#### **Maury Street Streetscape Phase 2**

#### **Urban Design Committee Meeting**

Revised for Final UDC December 11, 2025 (slide 20)

# **UDC Recommendations and Responses**

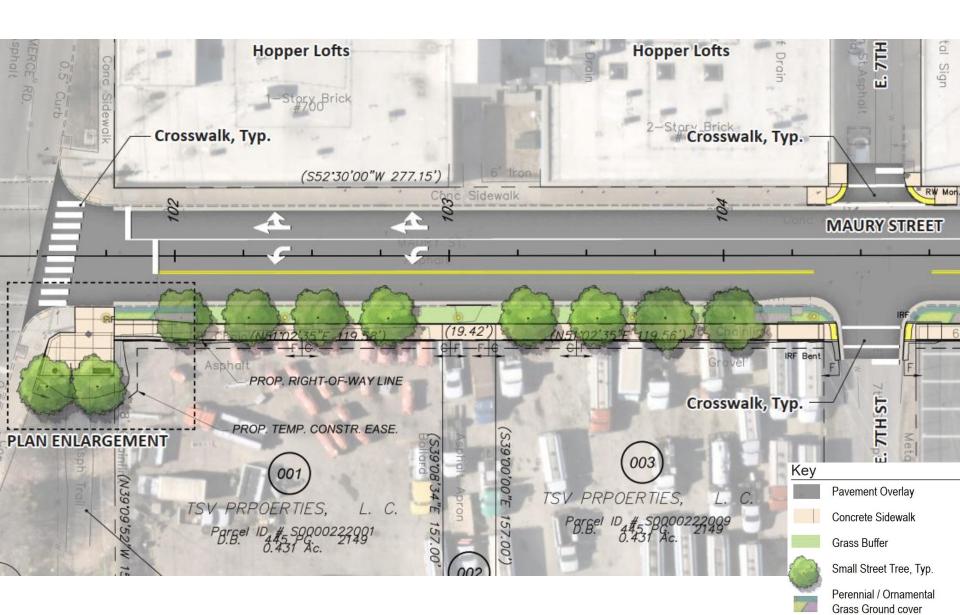
- 4. Applicant to study the feasibility of providing pedestrian crosswalks at all Maury Street intersections.
- 5. Applicant to consider providing additional raised crosswalks across Maury Street and across 7th Street.

- A. For both Items 4 and 5: 7th Street north of Maury Street is not a public street and it is private property with no public access. 7th Street for this reason is not a good selection for a major pedestrian crossing of Maury Street as it does not draw pedestrians from the north. 6th Street is a better choice as it has public right of way that extends from Dinwiddie Avenue to Decatur Street or eight full city blocks. It is also a center spine street midway between Commerce Road and 4th Street. Further, the intersection of 7th Street and Maury Street is too close to the major intersection of Maury Street and Commerce Road and sits well within the operational influence area of the larger intersection at just 240 feet, which will routinely place queued vehicles across the 7<sup>th</sup> Street intersection. 6th Street is 550 feet from Commerce Road and 470 feet from the 4th Street Roundabout which is the most even spacing available with the existing street network. Locating the PHB at 6th Street crossing creates a more even distribution of controlled crossings for people of all ages and abilities. The proposed design mitigates these issues.

## **Commerce to 6**<sup>th</sup> Recommendation 1 – Tree Spacing and Species

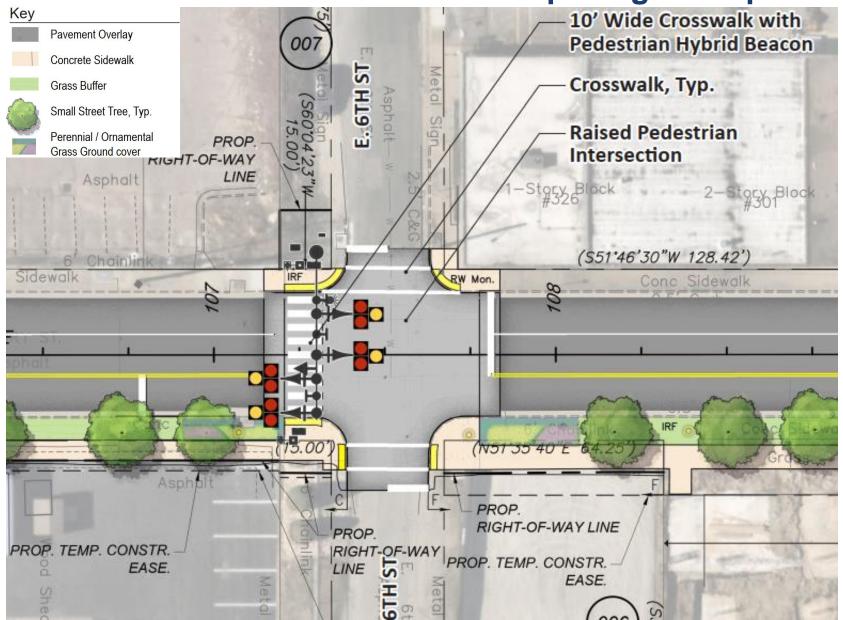
- 1. Applicant to evaluate street tree spacing and select appropriate native species for inclusion in the final landscape plan submission.
  - A. Street tree species were specified by City Urban Forestry because the selected species have vertical root systems suited to the underground stormwater management system. The three species are proposed to be randomly placed. The spacing will be regular; however, proximity to existing utility poles and future light poles require the spacing to be adjusted. Final spacing includes shifted tree locations and gaps to accommodate this infrastructure.

- B. Low-maintenance native ground cover species have been added for portions of the buffer strip area in lieu of standard grass mix.
- 2. Applicant to assess alternative material options for use at intersections.

### Recommendation 1 – Tree Spacing and Species Recommendation 3 – Parallel 5<sup>th</sup> St. Crosswalk

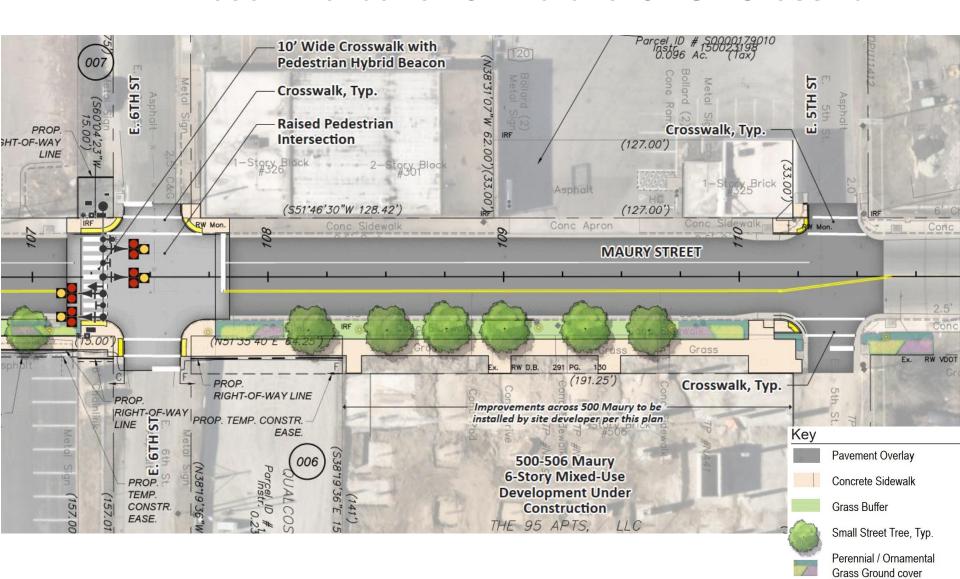
- 3. Applicant to consider revising the 5th Street intersection crosswalk to be aligned perpendicular to the roadway rather than diagonal.
  - A. This crosswalk has been aligned perpendicular to 5<sup>th</sup> Street.
